RE: JMC Project 20101
Summit Club Residential
Bedford Road (Route 22)
Town of North Castle, NY

Response to Town Comments Resubmission

Town of North Castle Planning Department, dated December 9, 2020

ROAD A FIRE TRUCK TURNING ANALYSIS

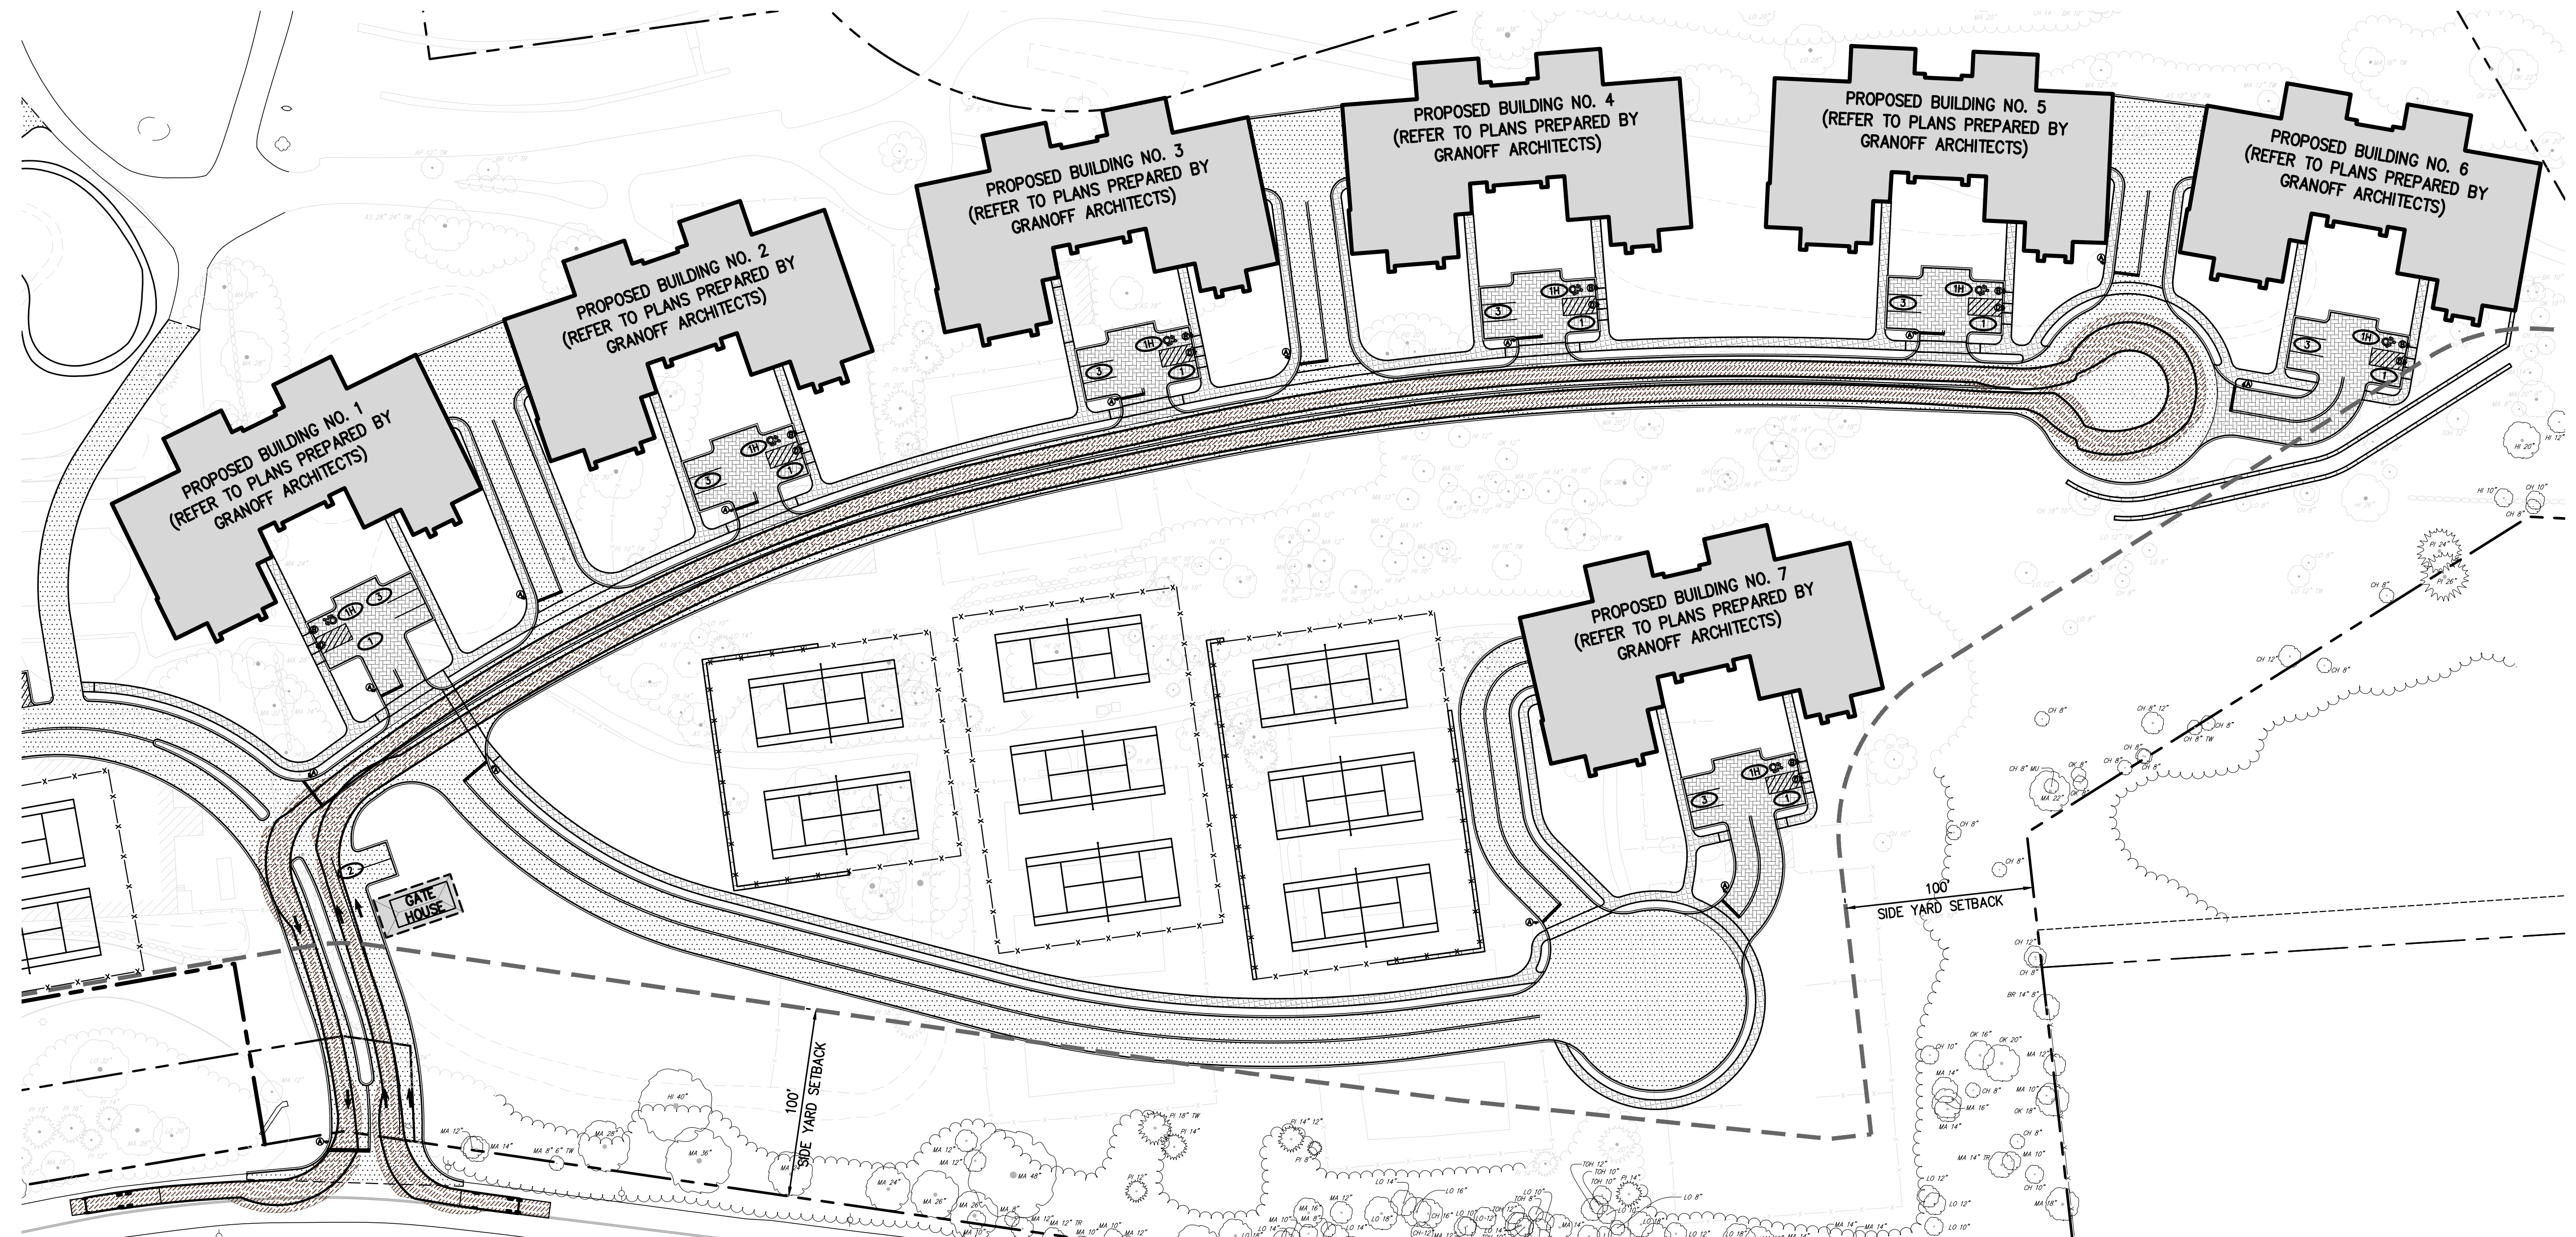
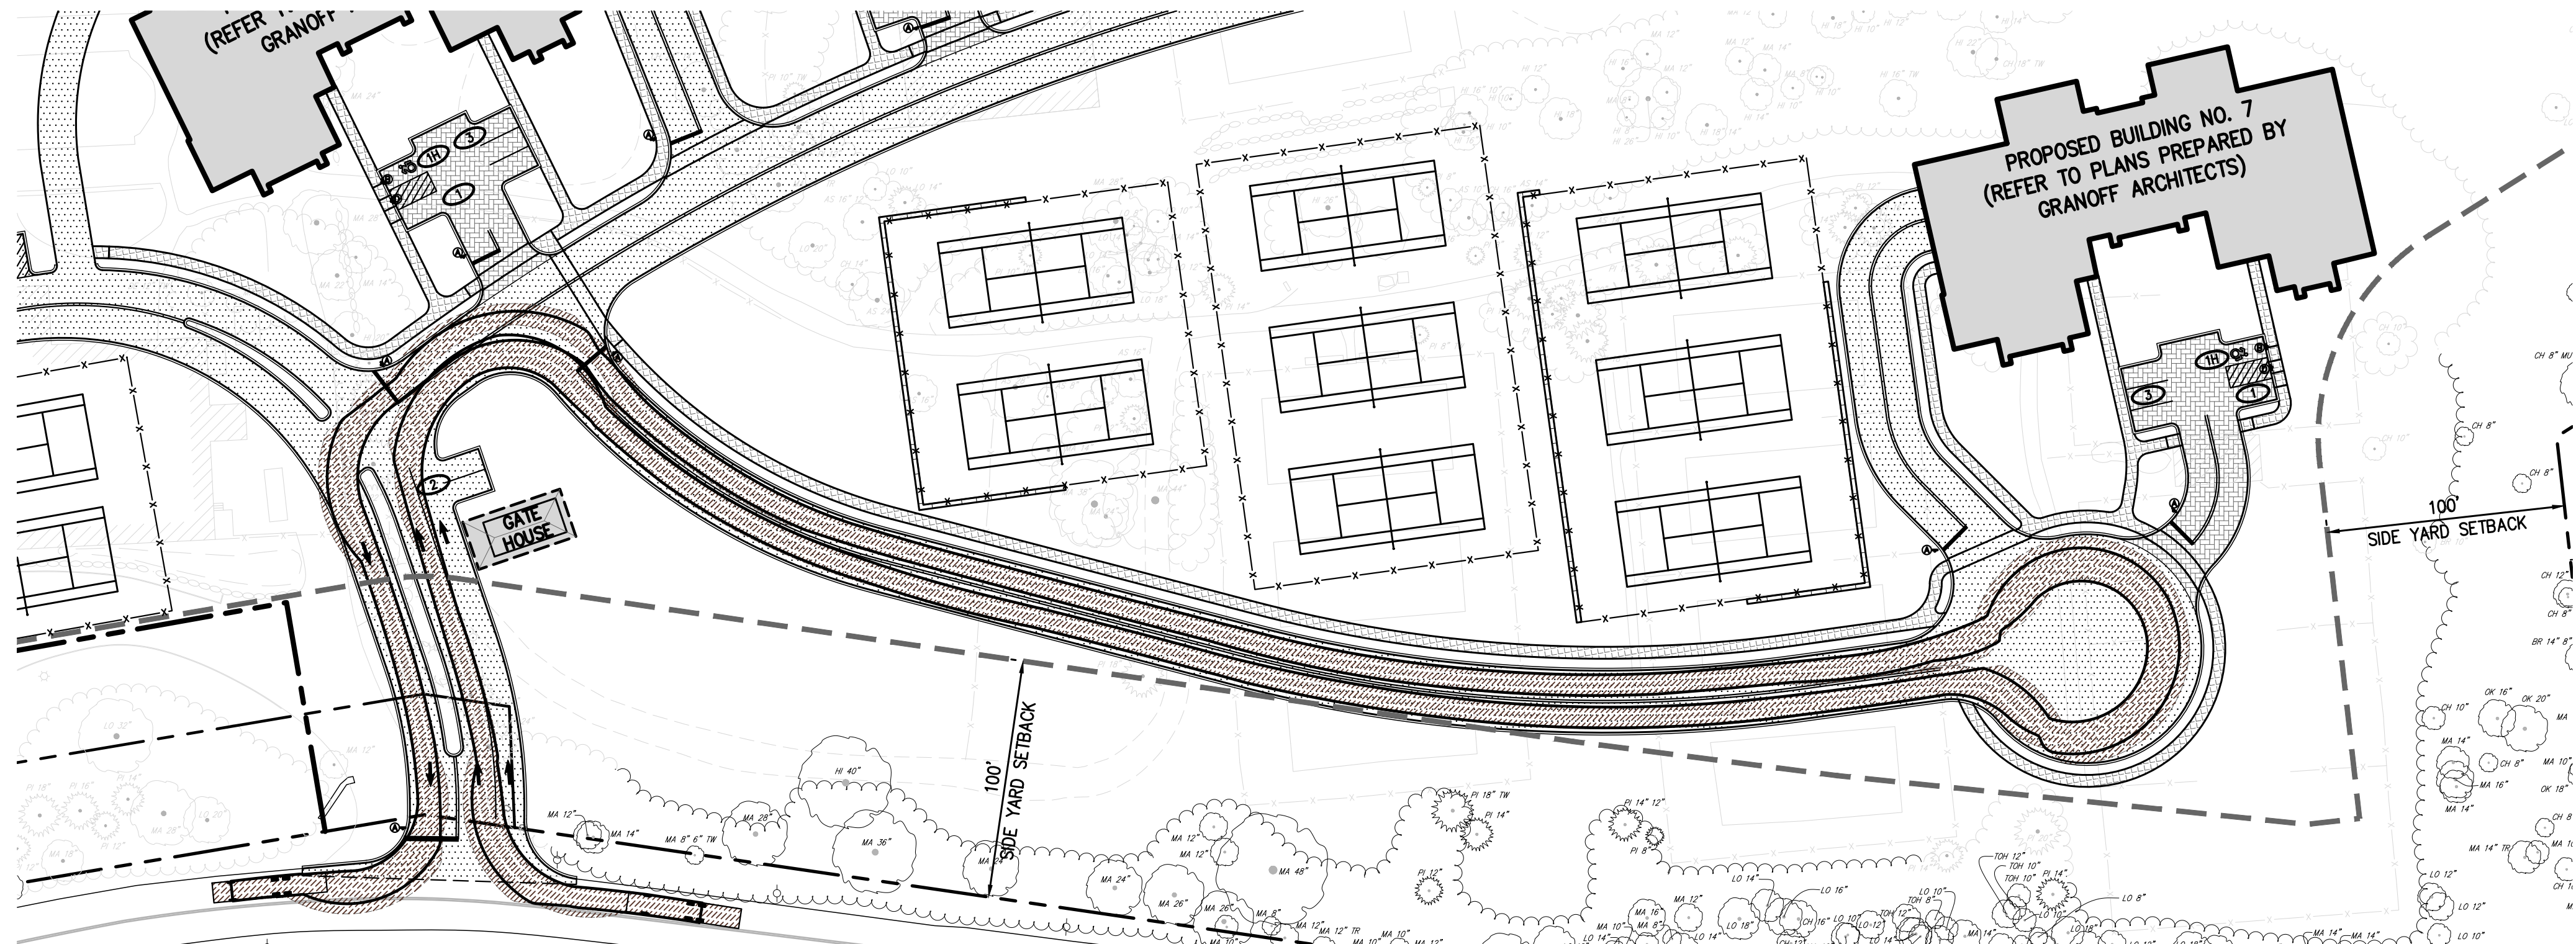
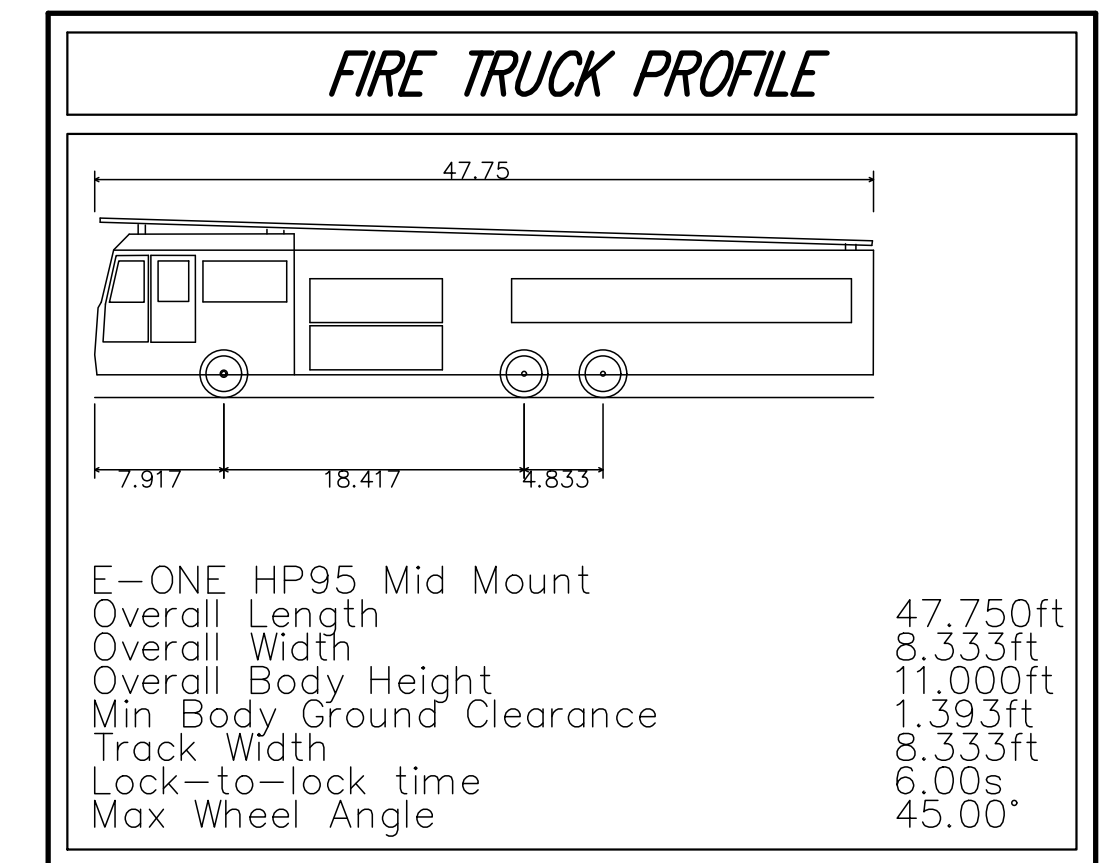
The plan proposes a temporary club house trailer, tent, mobile bathroom facility, food truck and patio area to service the existing Golf Course. All of these improvements are proposed within the existing parking lot located on Lot 1. The applicant will need to provide floor plans, design of the various utility services (sewer, water, storm, electric, etc.), construction details, etc., associated with these improvements. An evaluation of the loss of parking associated with the development of the proposed facilities within the parking lot should also be provided. In addition, the plans shall include a phasing plan to clearly illustrate how these facilities are to be developed and appropriately accessed for safe use in the near future, as well as during

construction of the residential development and amenities building in the future. A detailed construction sequence and phasing plan shall be developed for review. We would recommend that this plan be referred to the Fire Department for review of adequate emergency access.

A separate Site Plan application has been filed with the Planning Board for the temporary clubhouse facilities. Cutsheets of the various temporary structures have been included in the submission as well as a fire truck turning analysis. Utilities will be provided as follows:
